MOUNT POLLEY MINING CORPORATION
MOUNT POLLEY MINE
TAILINGS STORAGE FACILITY

ADDENDUM TO REPORT ON CYCLONED SAND CONSTRUCTION OF STAGE 3 AND ON-GOING STAGES OF THE TAILINGS STORAGE FACILITY
(REF. NO. 11162/13-4)

ATTENTION: Mr. George Headley **RE:** Stage 3 Addendum Report

FIGURE 3.2

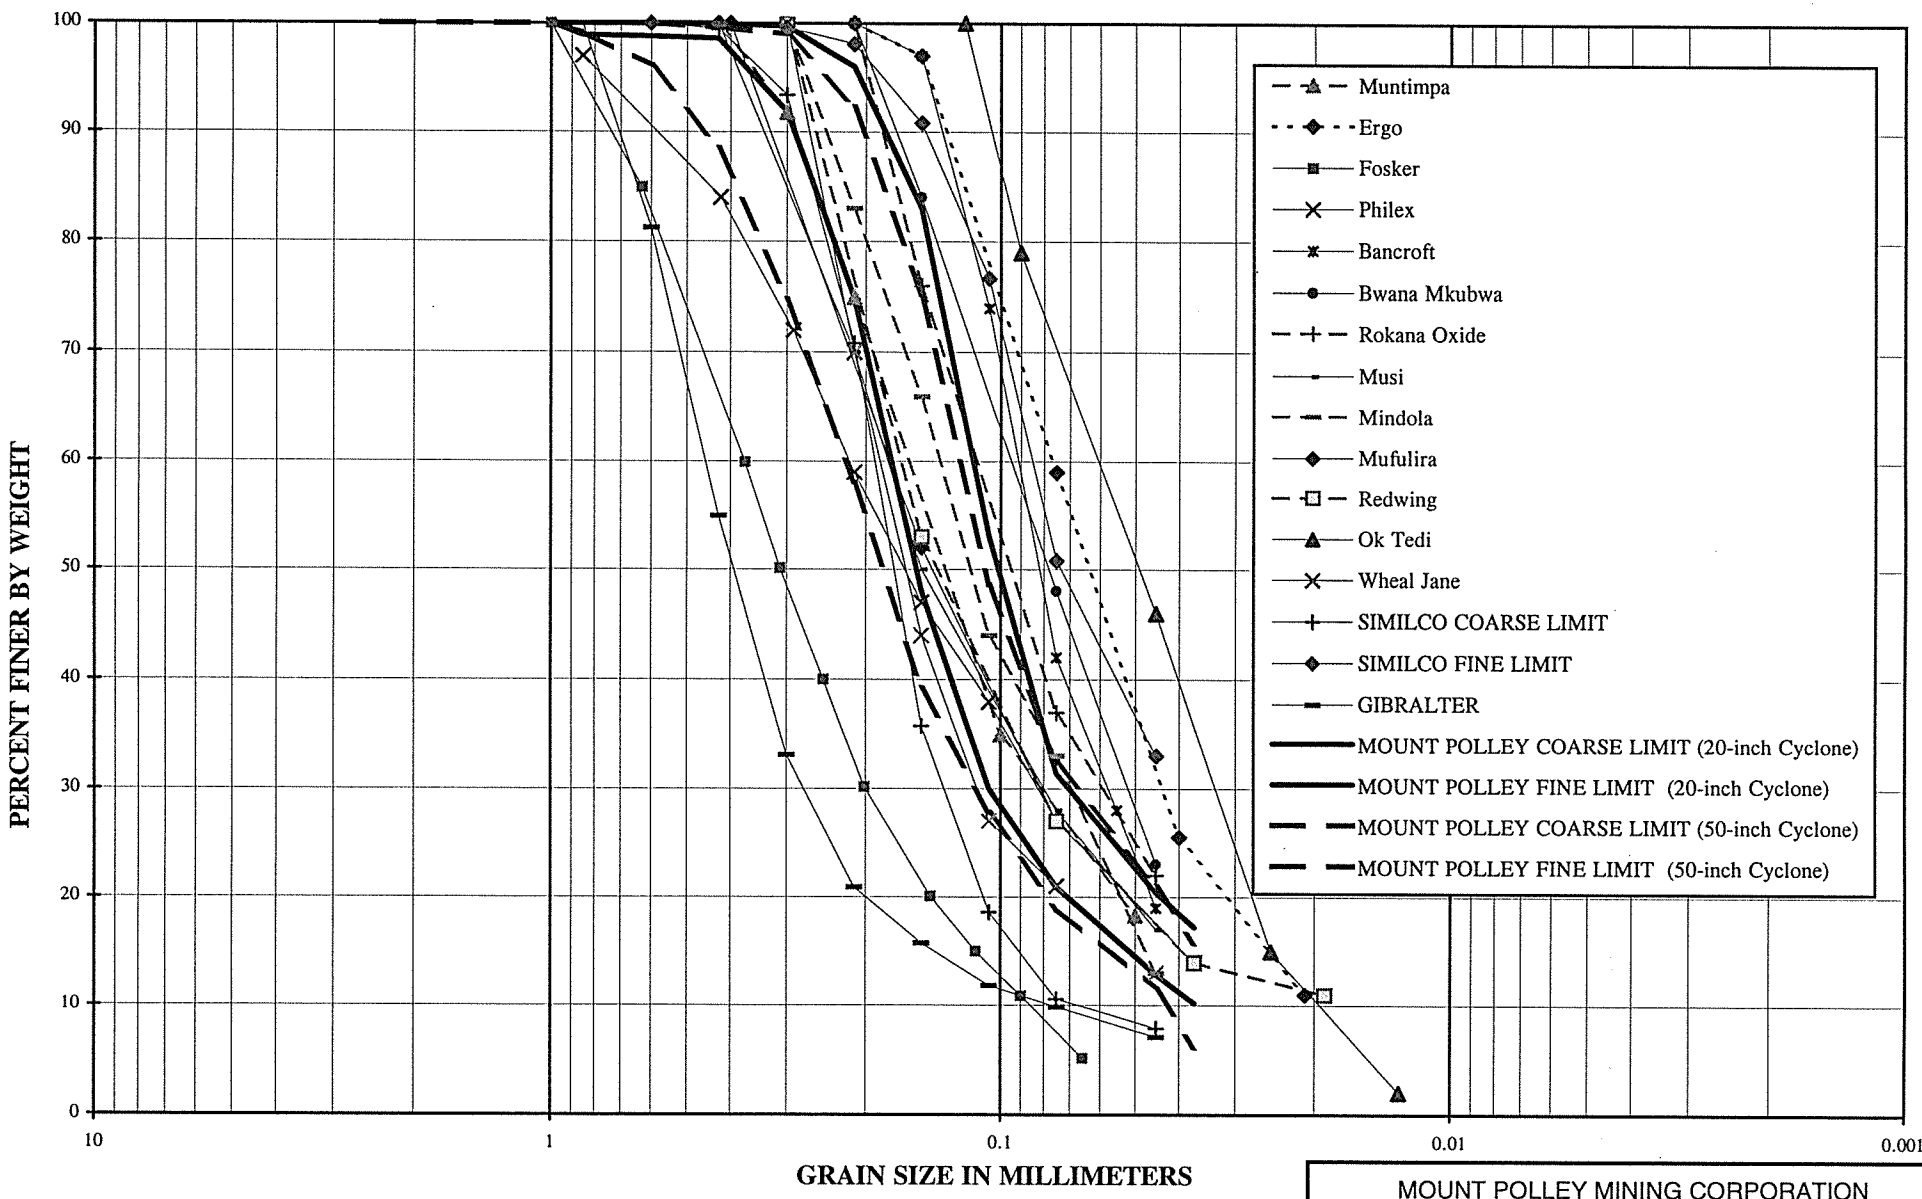
water-retaining dam. Specifically, the drains act to depress the phreatic surface within the tailings storage facility, thereby reducing overall seepage gradients through the embankment core zones, and convey seepage waters directly to the seepage collection and recycle facilities and minimize the opportunity for losses to the environment via any previously-undetected permeable foundation layers. The effects of inclusion or exclusion of the toe drain on the phreatic surface of the embankment are shown schematically in the generalized sections of Figure 3.2.

Reduced seepage gradients and depressed phreatic surfaces translate directly into improved static and seismic embankment stability, reduced seepage losses to the environment, increased consolidation and densities of the tailings mass upstream of the embankment core zone. Furthermore, the toe drain installations and the resulting depressed phreatic surface provide the ability to monitor the long-term performance of the embankment structure with the flexibility and intent of eventually eliminating the requirements for the core zone in future raises of the embankment, with resulting cost savings. It is the opinion of Knight Piésold Ltd., based upon observation of existing structures and analyses of their performance, that the significant geotechnical, environmental and economic benefits associated with the upstream toe drains outweigh the minimal risks associated with properly designed and constructed outlet drains.

FIGURE 3.3

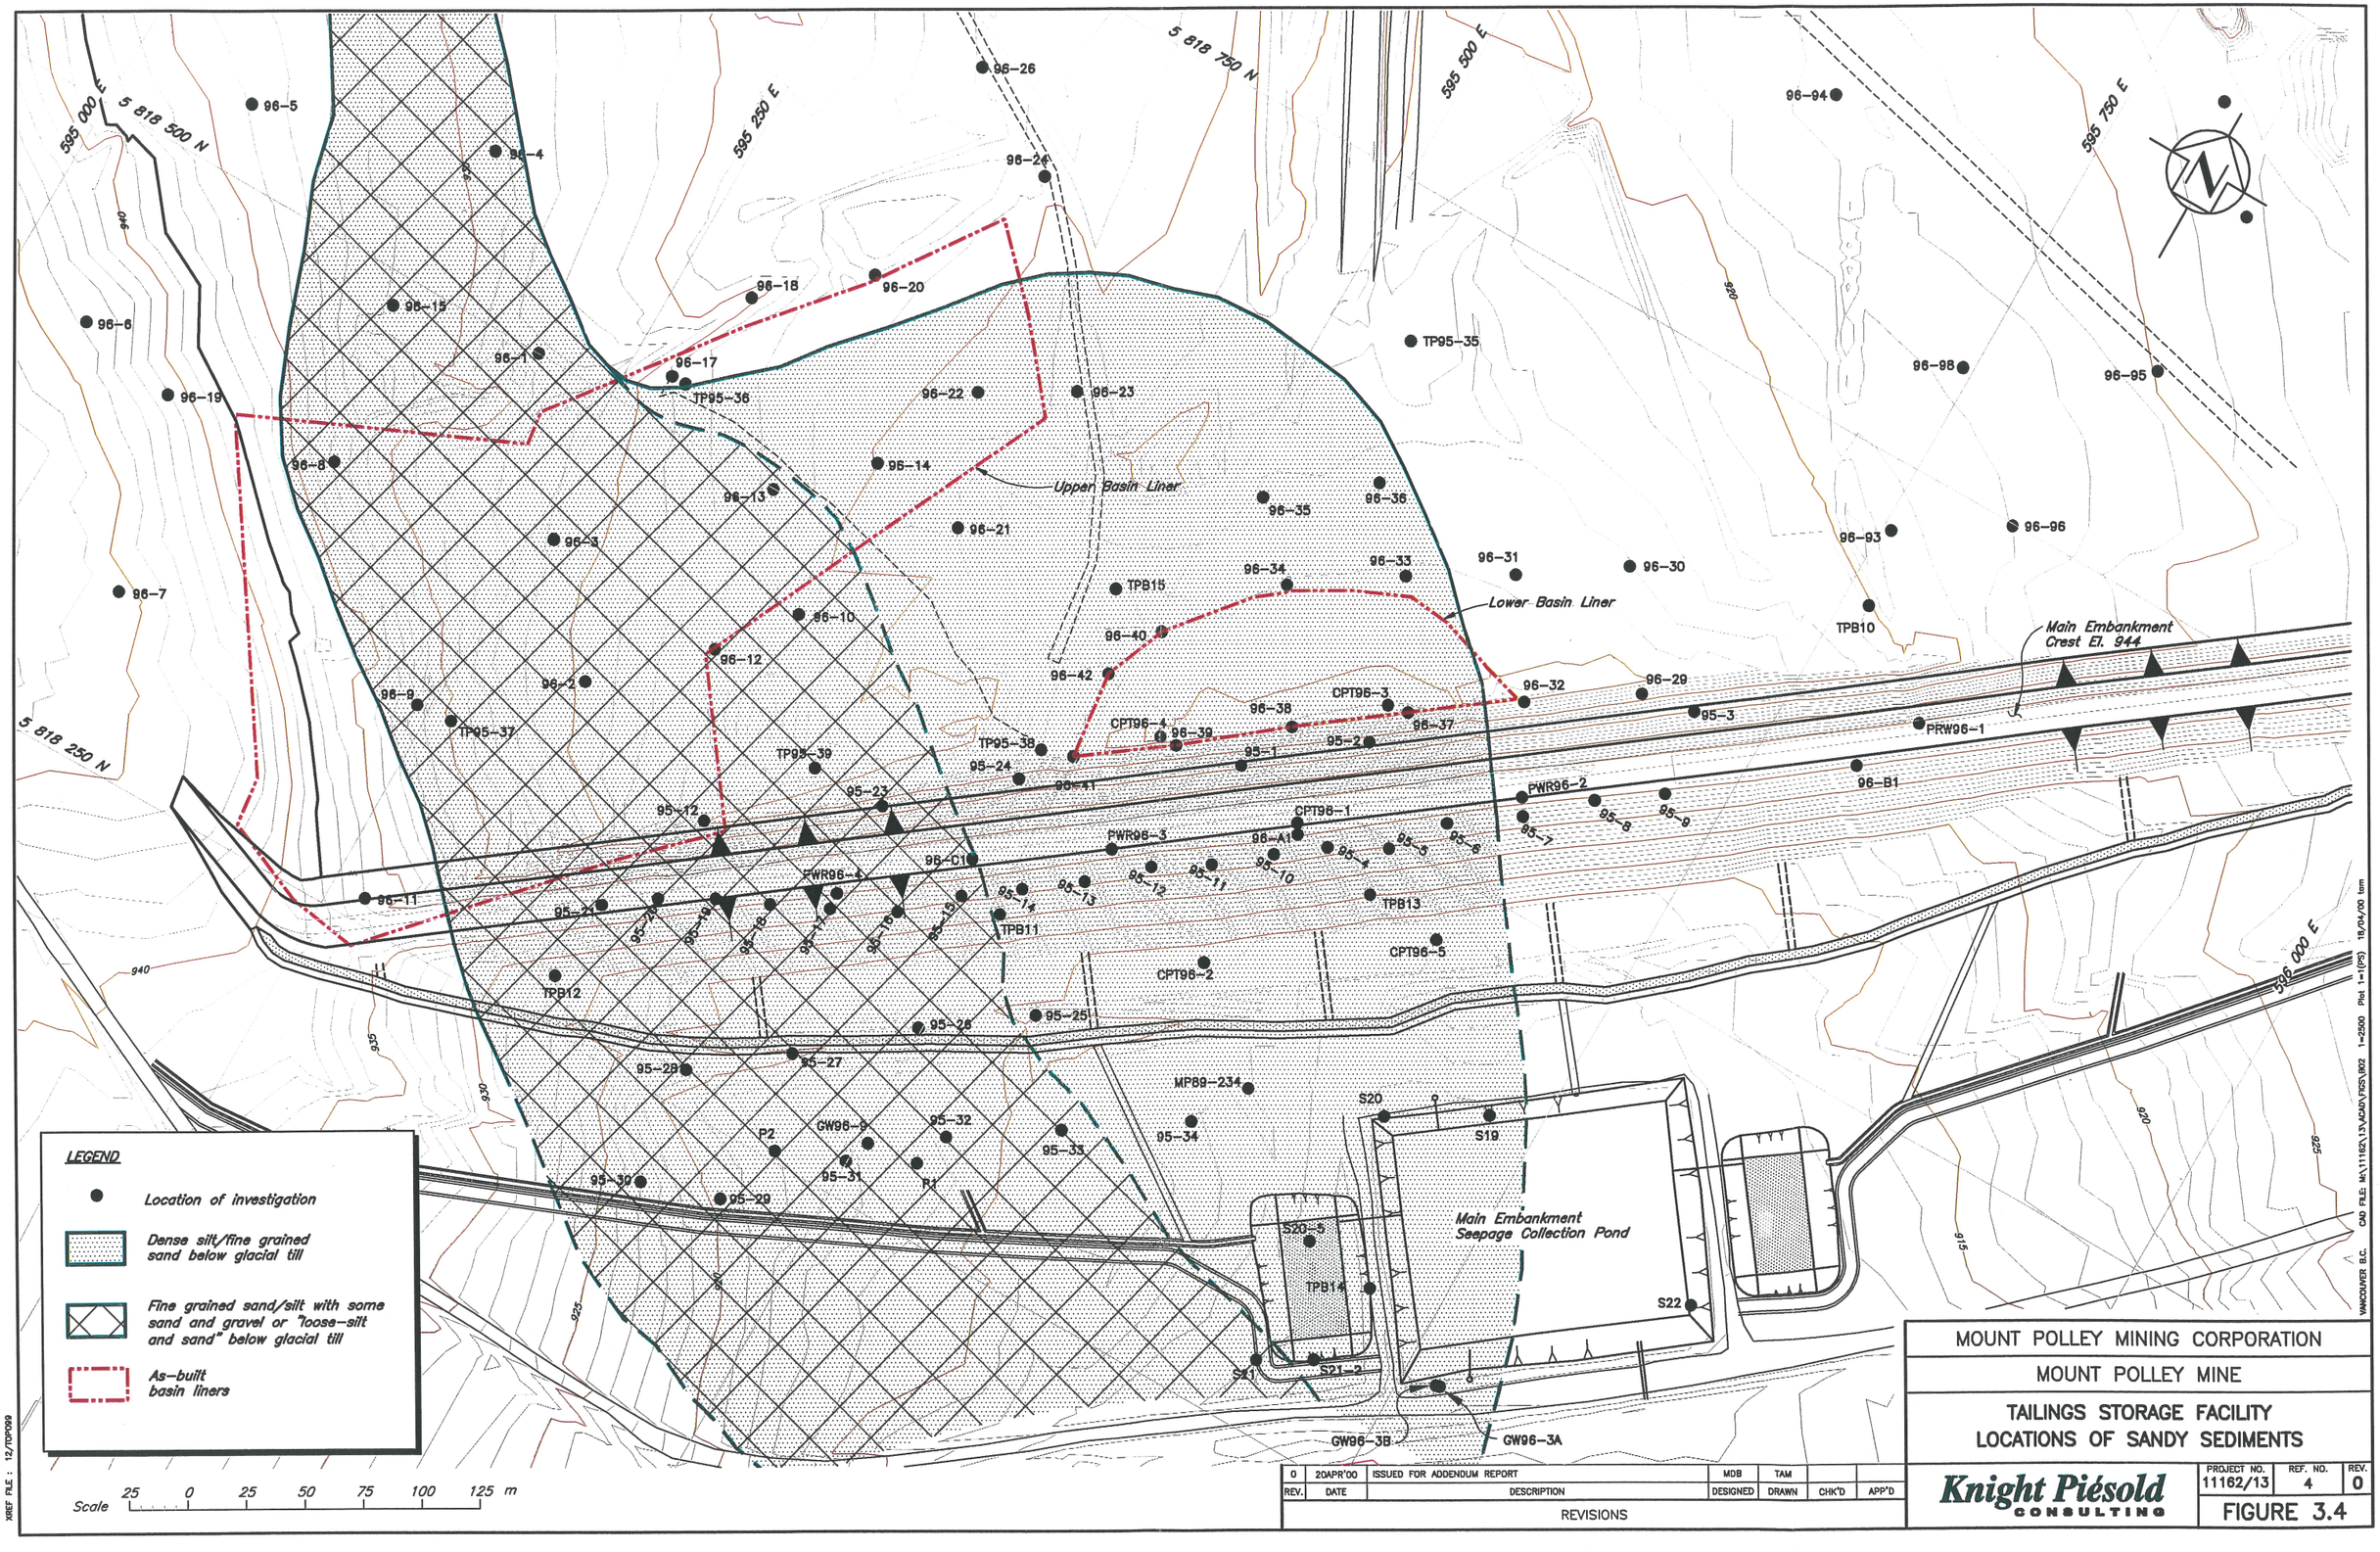
The use of the centreline method was successfully used at Gibraltar and Brenda Mines. It is recognized that the gradation of Mt. Polley is finer, therefore it is recommended that Knight Piésold – Mt. Polley Mines provide some further information such as:

these operating mines are summarized on Figure 3.3, which also includes additional information from the Similco and Gibraltar mines in British Columbia. The gradation of the Mount Polley cycloned sand underflow is also included on this figure for comparison. This information demonstrates that the Mount Polley cycloned sand underflow product represents an average gradation when compared to these mines (the gradation plots in the middle of the distributions from the other mines). It should be noted that the data for the MPMC underflow product was obtained during the trial programs and it is felt that a full-scale, optimized cycloning system will produce a cleaner (more free draining) underflow product as previously discussed.

FIGURE 3.6

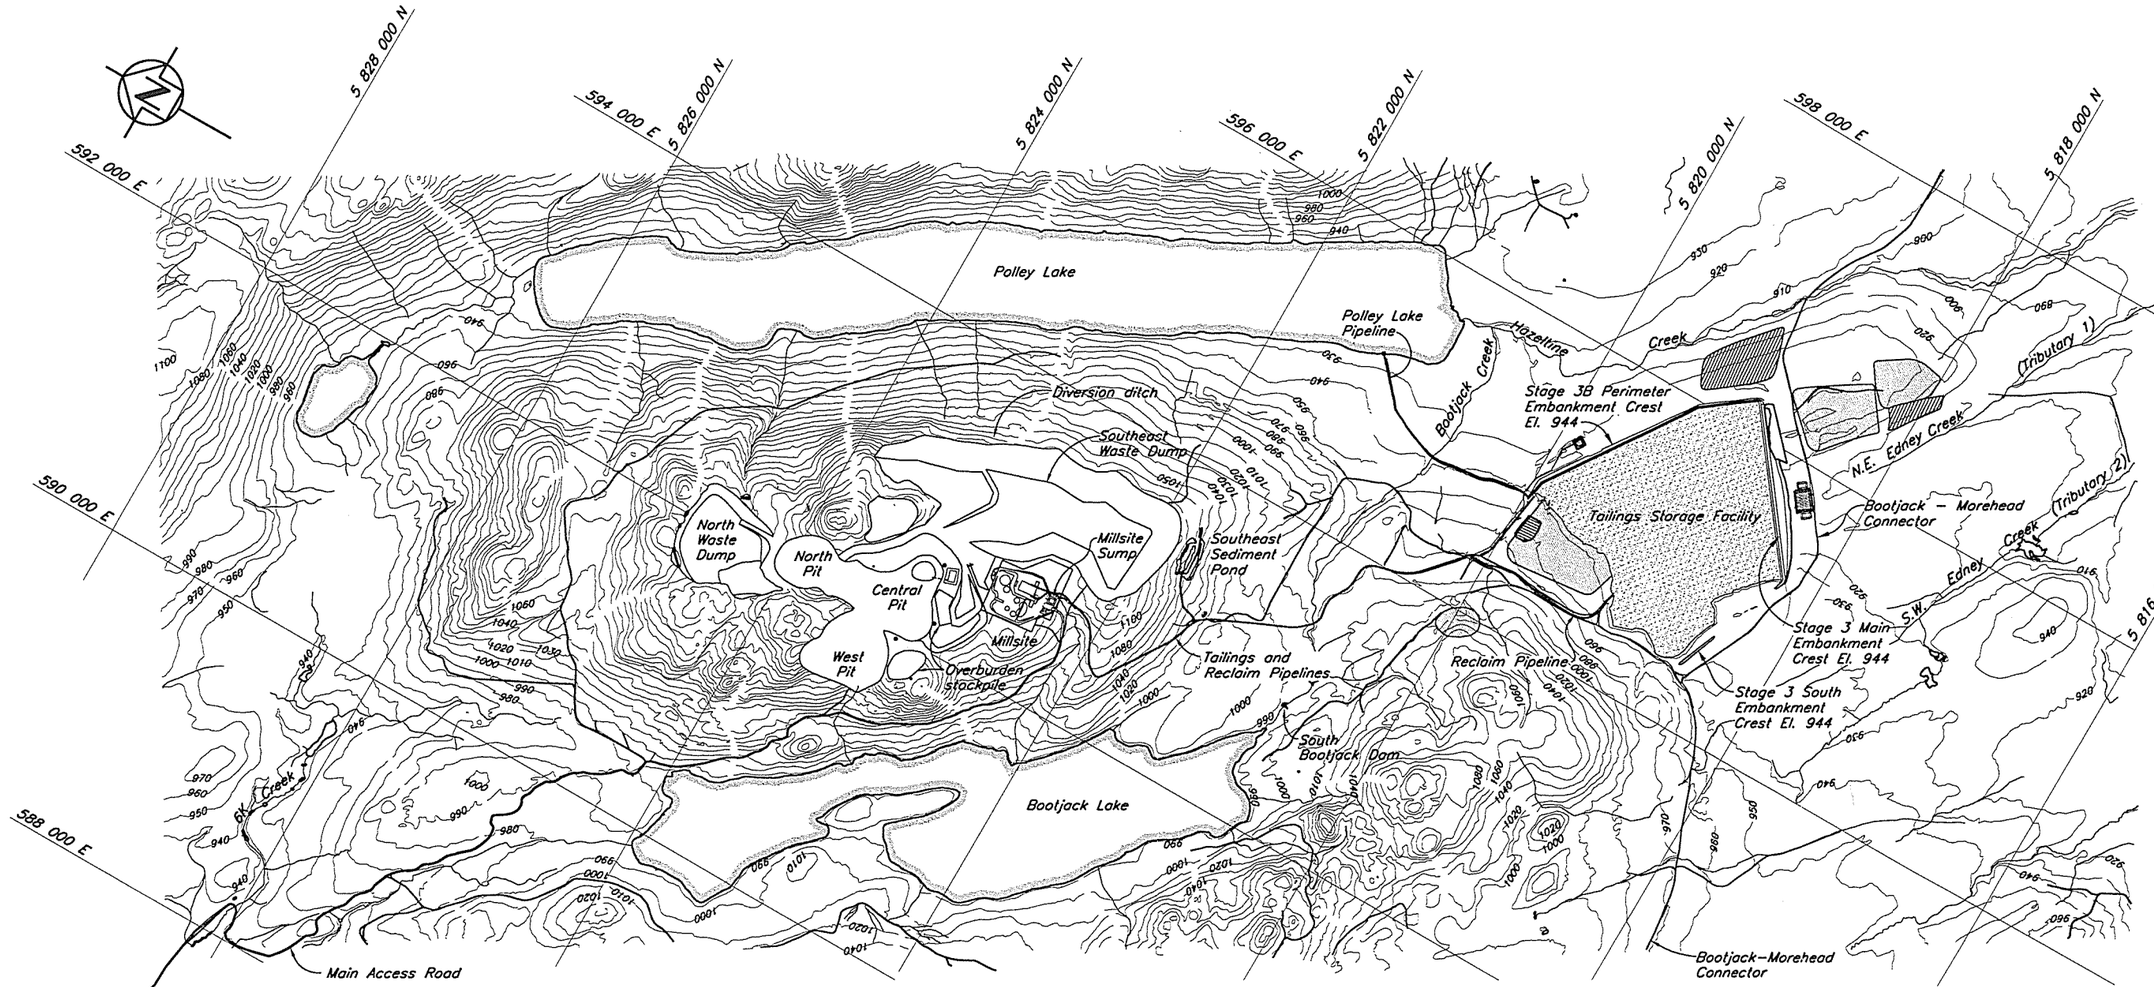
The temporary saturated condition will not occur during Stage 3 embankment construction, as only one hydraulically placed lift is planned. It is, however, a consideration for hydraulic placement in future stages of the embankment, and during deposition of underflow sand in Stockpile A. Therefore, an analysis of the

The stability analysis indicates an acceptable FOS against sloughing of the cycloned sand during hydraulic placement, and against deep-seated circular failure for on-going stages. The embankment and drain systems will be monitored and reviewed on an on-going basis to verify that the embankment is performing within the design tolerances.

The results of the analyses are summarized on Figure 3.6.
